1 Products affected

2 Type of change

3 Detailed description of change

Old product appearance (example)	New product appearance (example)

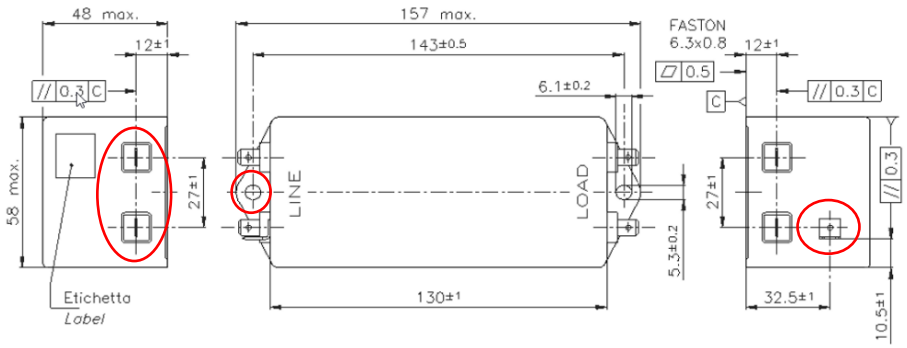
- Change of product appearance due to new nickel plated case instead of aluminium case and different shape of plastic part for quick connect terminals see photo below
- Different shape of plastic part for external quick connector terminals
- Position of earth terminal

Case MB with quick connect terminals

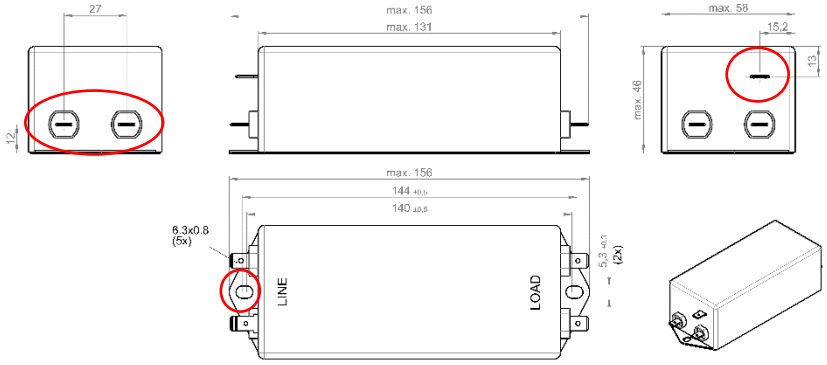
- Nickel plated case instead of aluminium case
- Different shape of external quick connect terminals
- Changed ground terminal position
